ORIGINAL MOUNT VERNON HIGH SCHOOL

CURTAINWALL/STOREFRONT SHOP DRAWINGS

VMO ARCHITECTS

PROJECT NUMBER:
24-323

DC3 ELEVATION DC3
E1A DRAWING SCALE
24x36: 1/2" = 1'-0"
11x17: 1/4" = 1'-0"

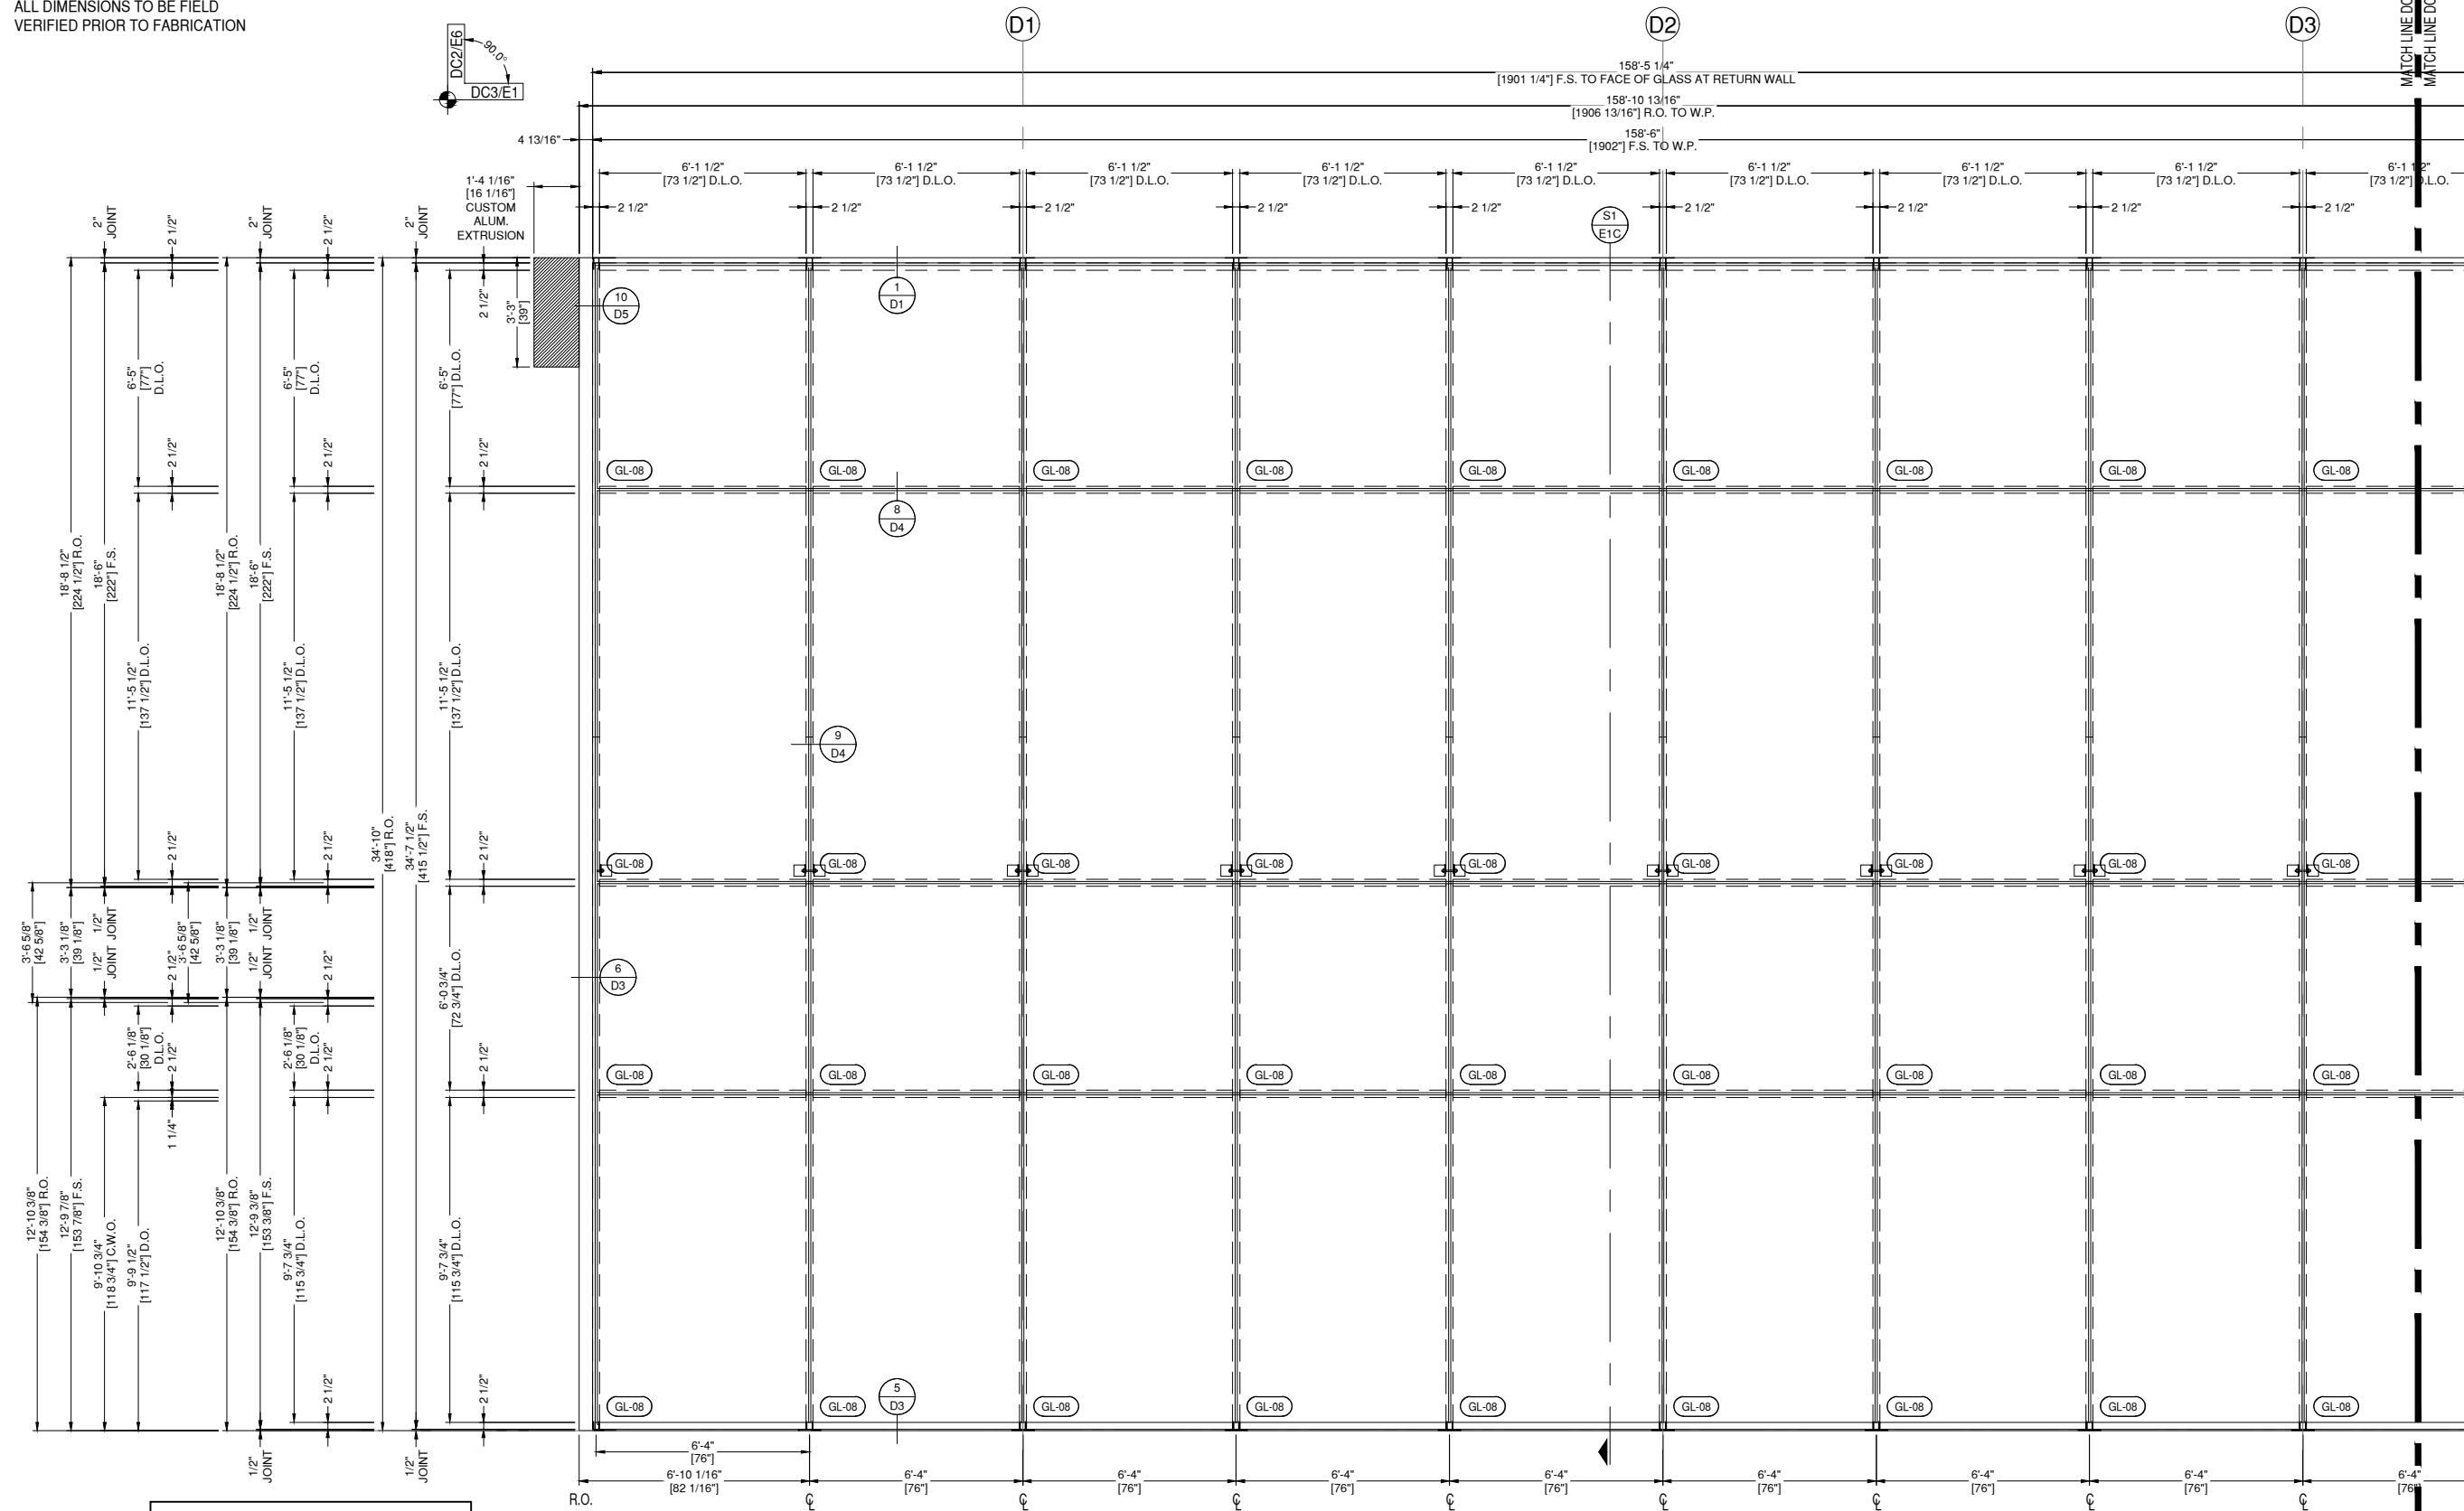
ARCHITECT NOTE:
HORIZONTAL MULLIONS HAVE BEEN
ADJUSTED AT THIS FRAME TO MATCH
DOOR SCHEDULE. PLEASE CONFIRM.

DC5 ELEVATION DC5
E2 DRAWING SCALE
24x36: 1/2" = 1'-0"
11x17: 1/4" = 1'-0"

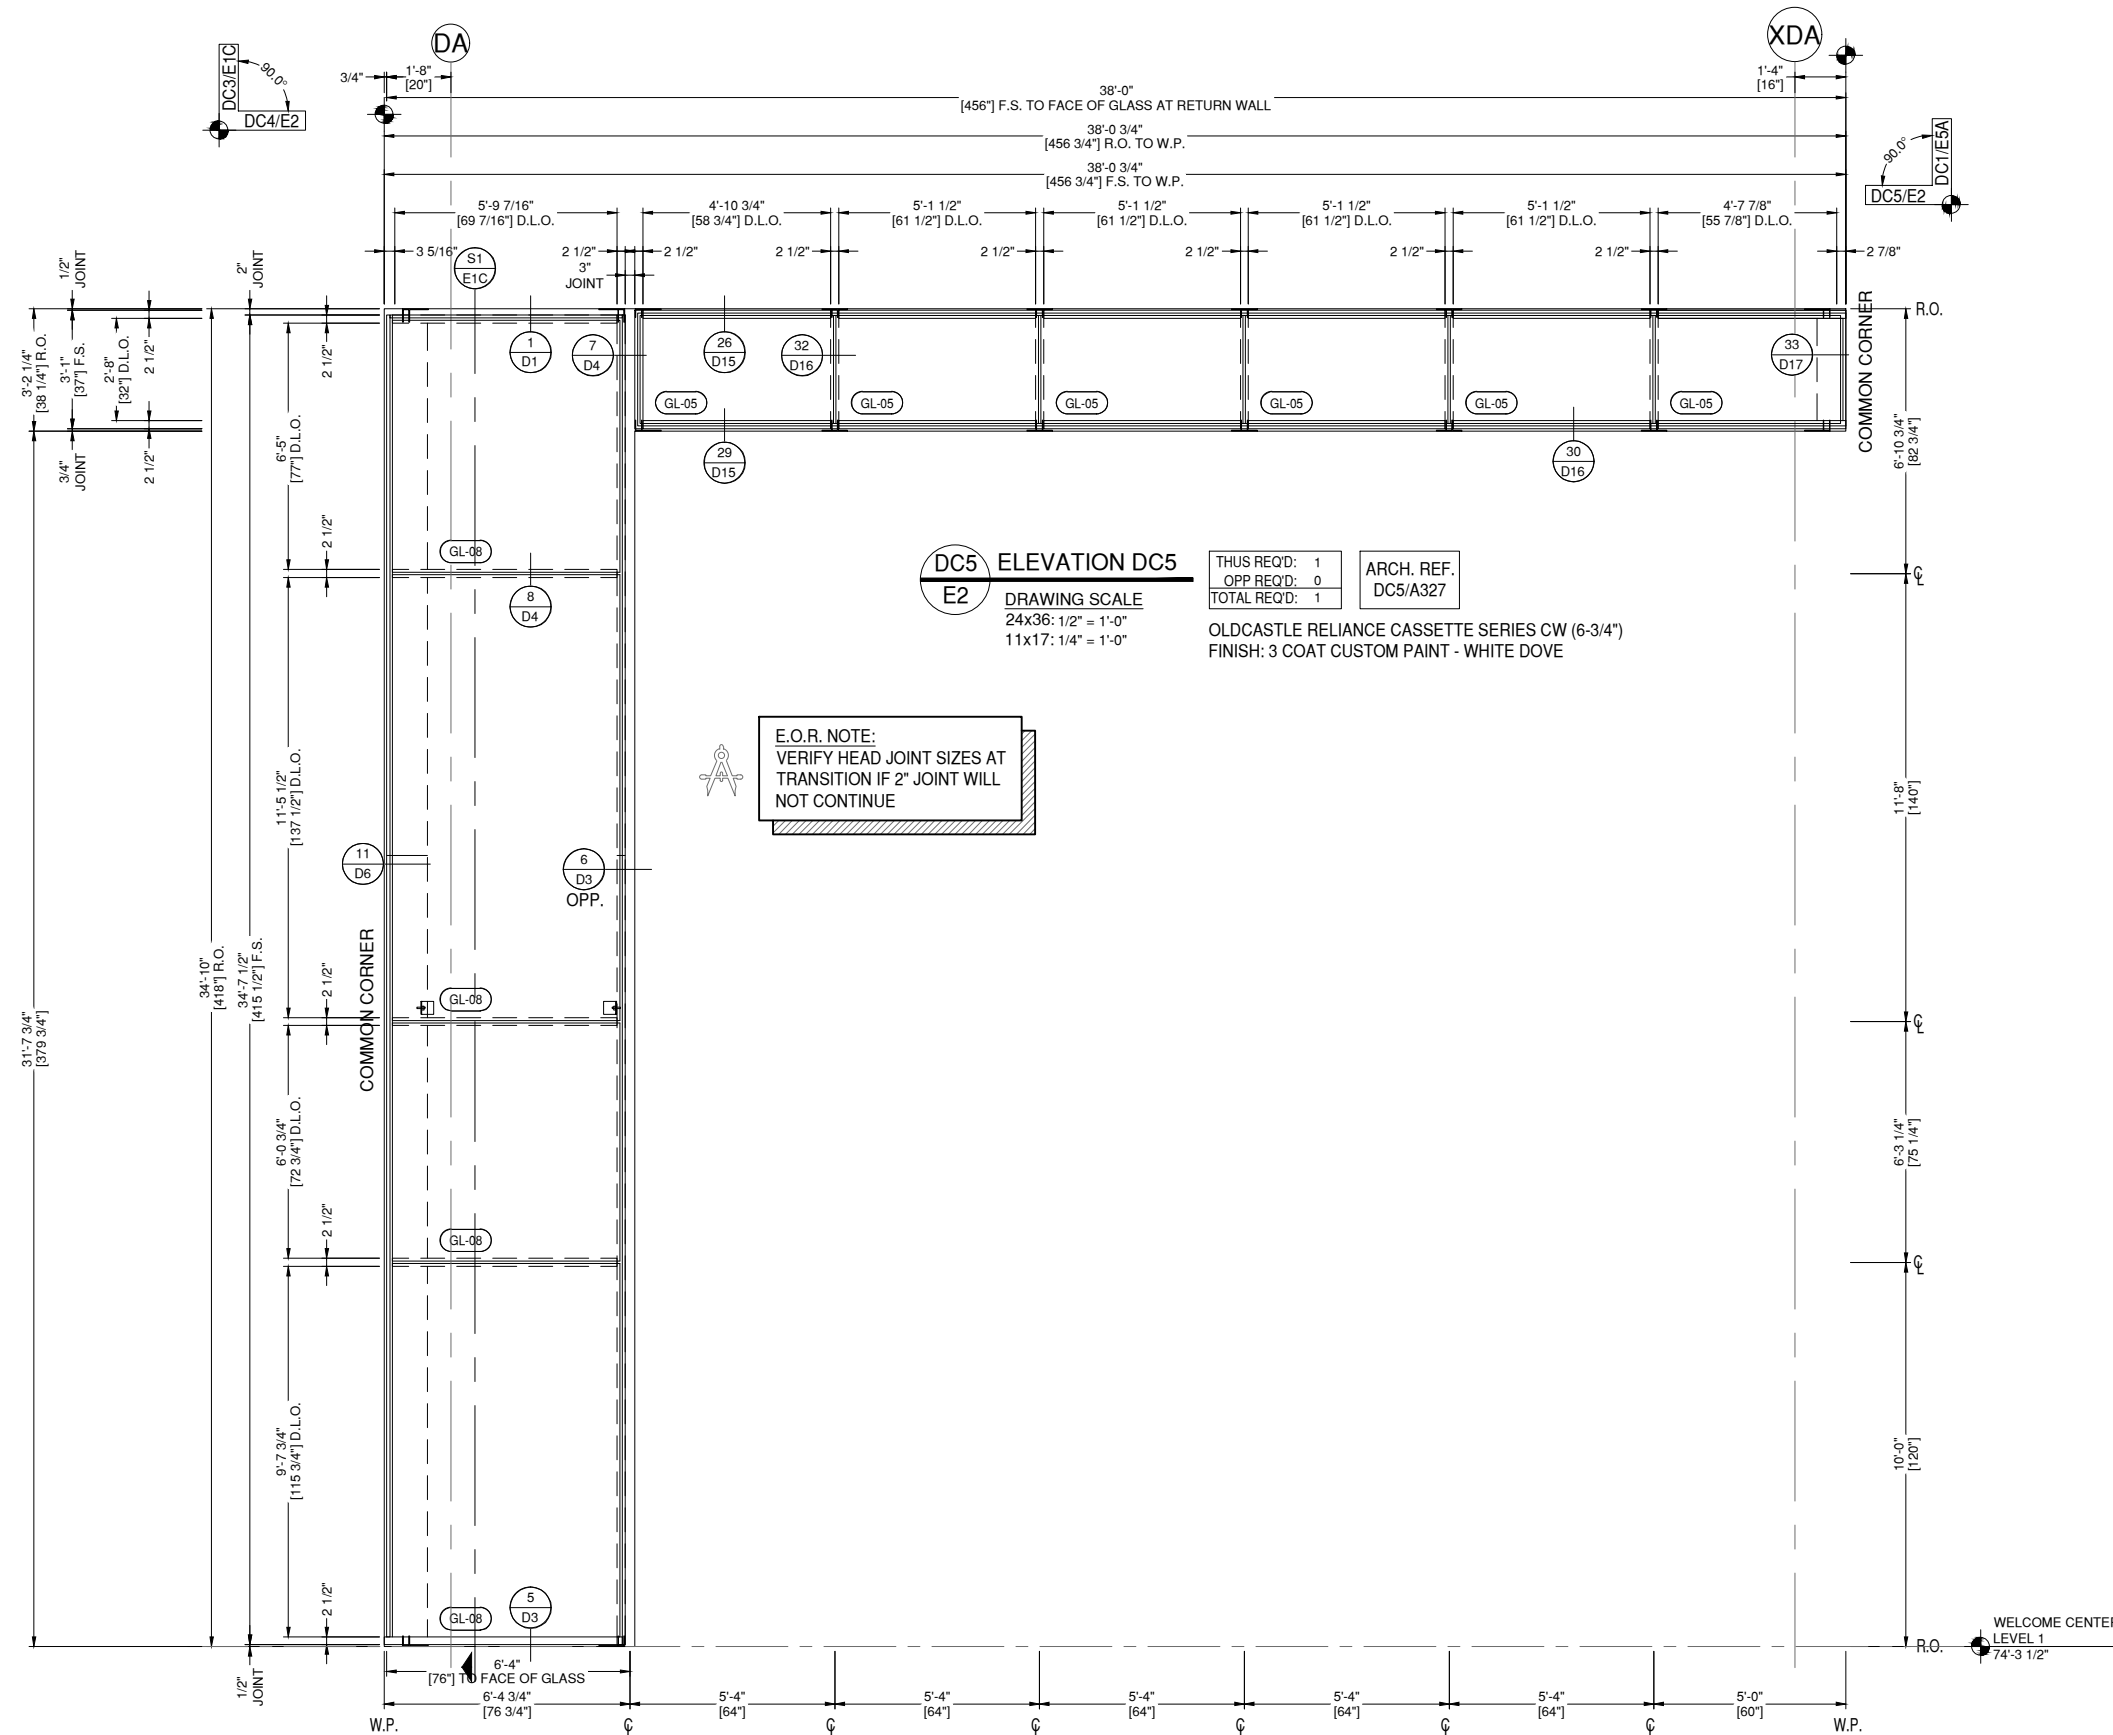
E.O.R. NOTE:
VERIFY HEAD JOINT SIZES AT
TRANSITION IF 2" JOINT WILL
NOT CONTINUE

DC7 ELEVATION DC7
E3 DRAWING SCALE
24x36: 1/2" = 1'-0"
11x17: 1/4" = 1'-0"

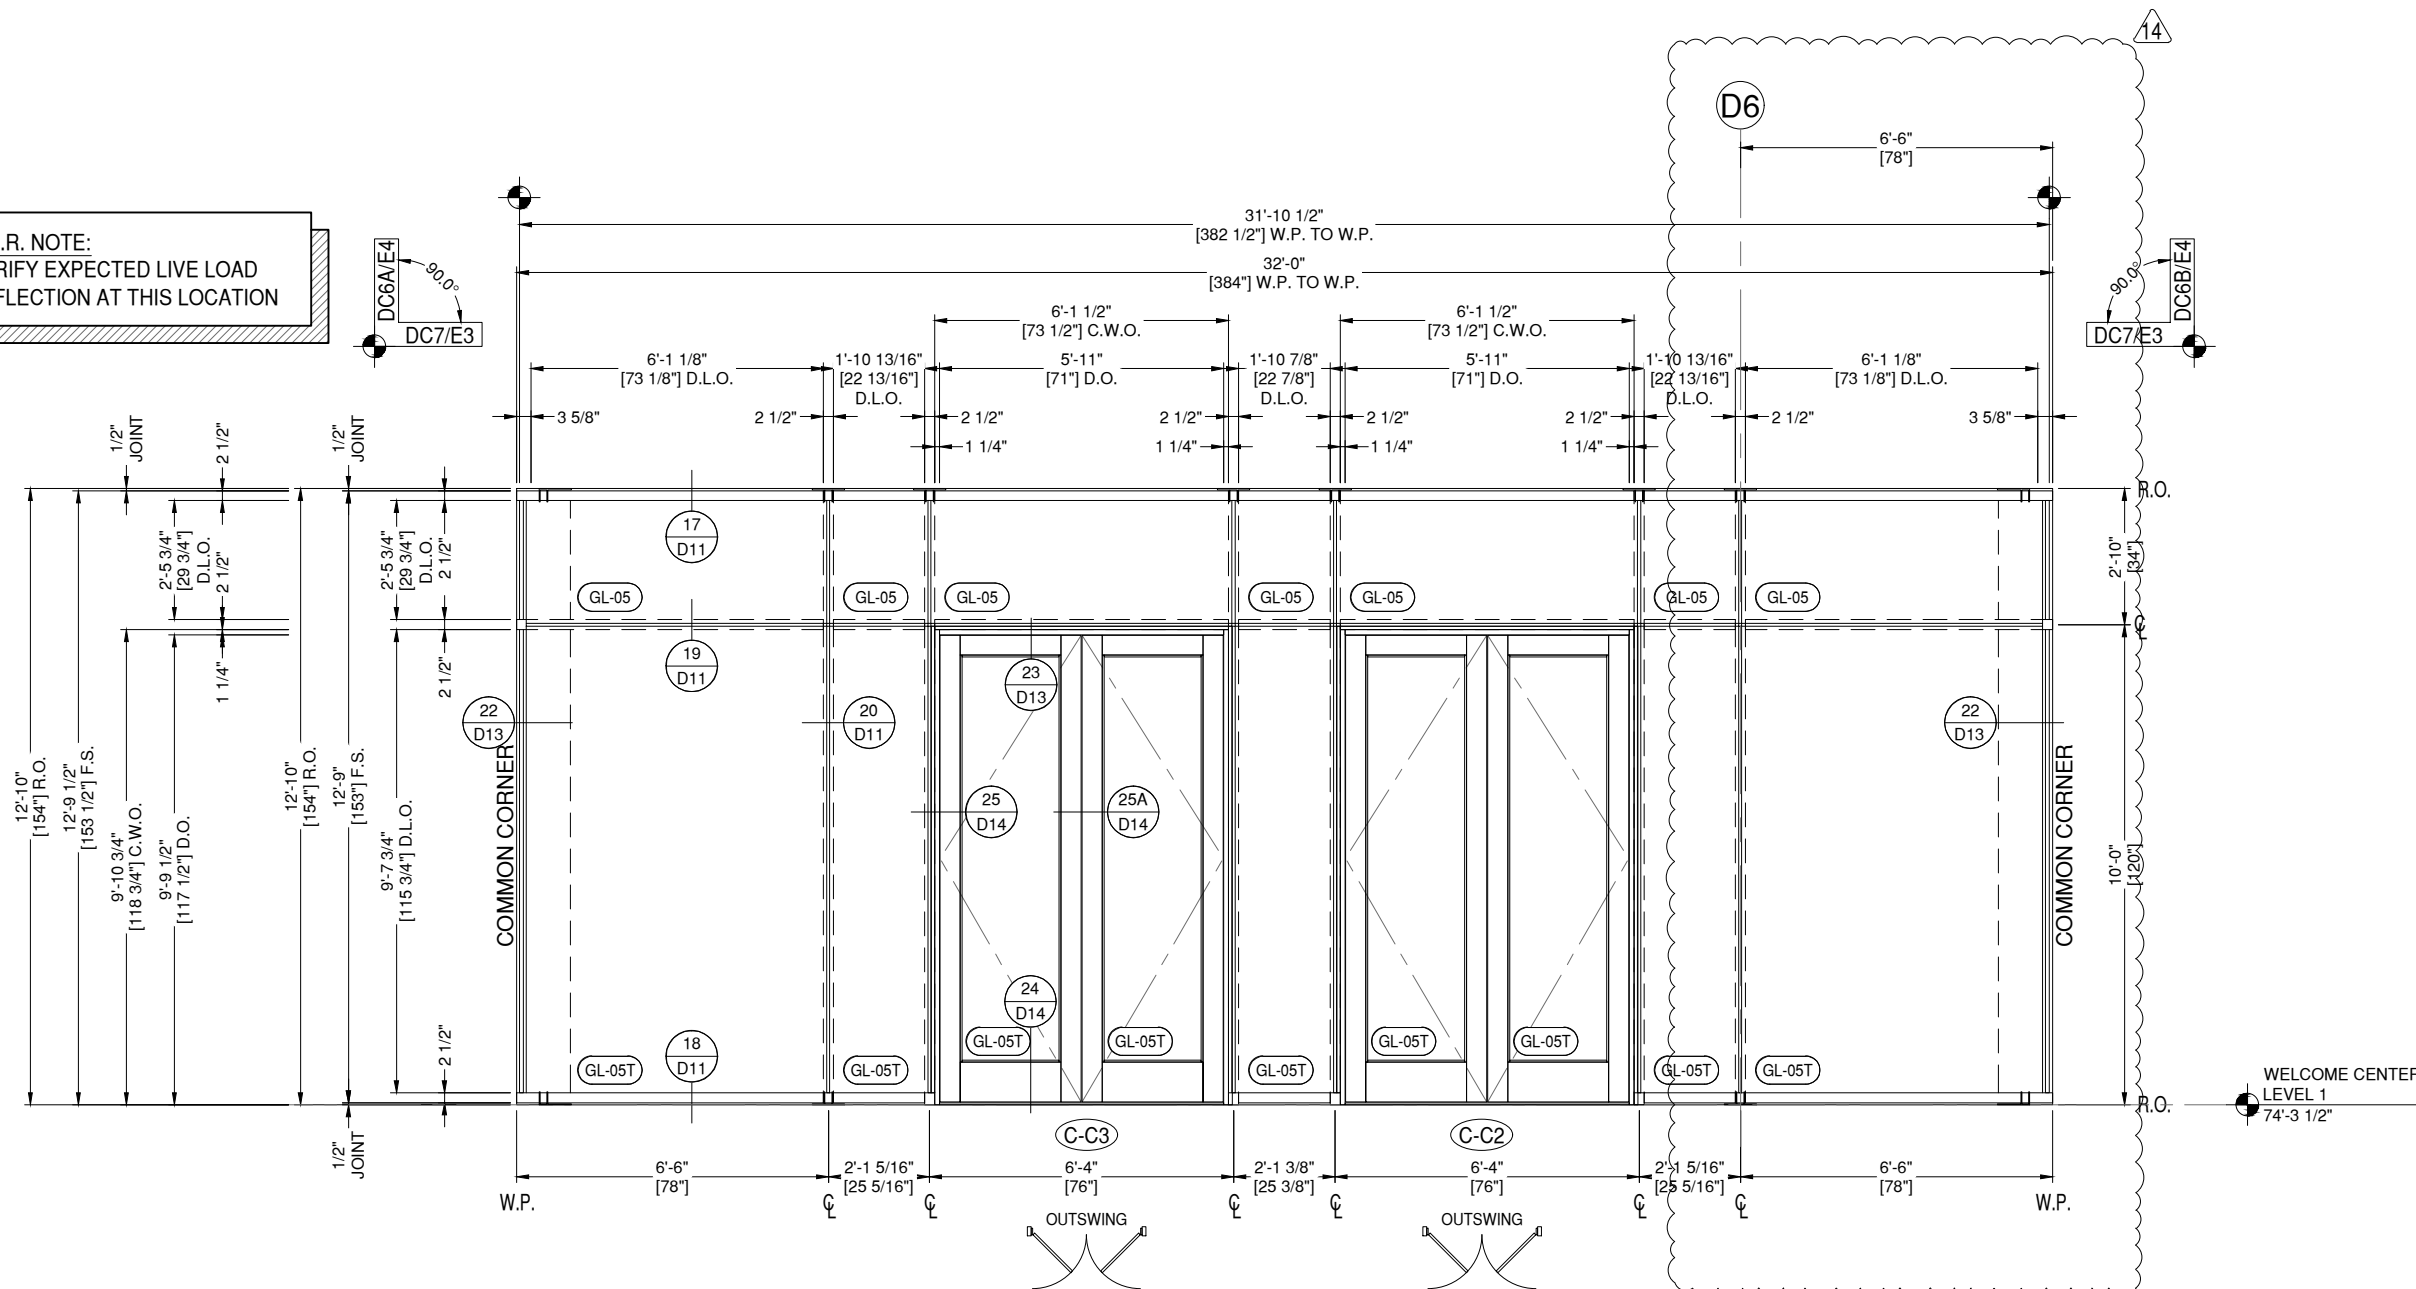
E.O.R. NOTE:
VERIFY EXPECTED LIVE LOAD
DEFLECTION AT THIS LOCATION
